# Access Compliance Report

## Public Rights-of-Way

Intersection ID: 47970	Main Street: KYRENE_RD	Cross Street: HAWK_SHADOW_LN	Location: SW
ADA ID: EB357466BBE1	Ramp Type: PerpDiag	Initial Pass/Fail: Fail	Overall Compliance: No
Severity Score: 10			
Codes/Mitigation Info/Possible Solution		Field Measurements/Component Compliance

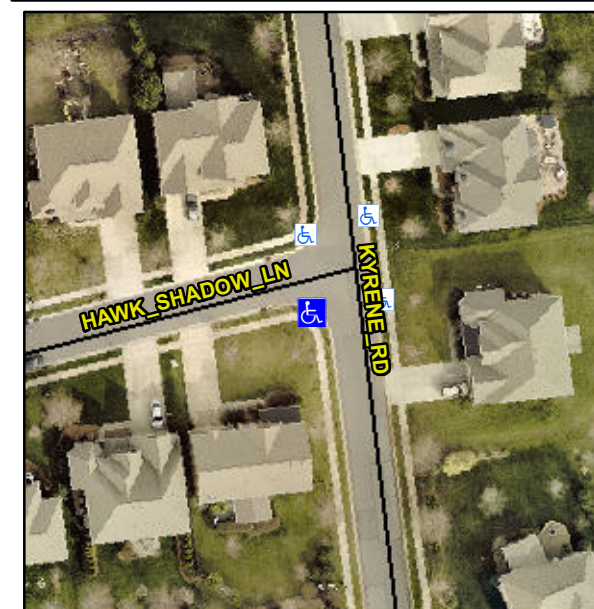
**Remove & Replace Curb Ramp With Two New Directional Ramps or Equivalent.**

**R304.5.1, R304.5.3**

Compliance	Description	Data	Compliance	Description	Data
N/A	Ramp Length (in)	48.0	Yes	Ramp Slope (%)	7.2
No	Ramp Width (in)	47.0	No	Ramp XSlope (%)	2.7
N/A	Flare Type LT	N/A	N/A	Flare Type RT	N/A
N/A	Flare Slope LT (%)	N/A	N/A	Flare Slope RT (%)	N/A
N/A	Flare Traversable LT?	N/A	N/A	Flare Traversable RT?	N/A
N/A	Landing Length (in)	N/A	N/A	DWS Provided?	N/A
N/A	Landing Width (in)	N/A	N/A	DWS Contrast?	N/A
N/A	Landing Slope (%)	N/A	N/A	DWS Length (in)	N/A
N/A	Landing X Slope (%)	N/A	N/A	DWS Full Width?	N/A
N/A	Landing Curb? (Y/N)	N/A	N/A	DWS Offset (in)	N/A
N/A	Shared Landing?	N/A			
N/A	Gutter Ponding?	N/A	N/A	Gutter Slope (%)	N/A
N/A	Gutter Lip Ht (in)	N/A	N/A	Gutter X Slope (%)	N/A
N/A	Painted X Walk1?	No	N/A	Painted X Walk2?	No
	X Walk 1 Direction	To E		X Walk 2 Direction	To N
N/A	X Walk 1 Width (in)	N/A	N/A	X Walk 2 Width (in)	N/A
	X Walk 1 Slope (%)	4.0		X Walk 2 Slope (%)	1.6
	X Walk 1 X Slope (%)	0.2		X Walk 2 X Slope (%)	2.8
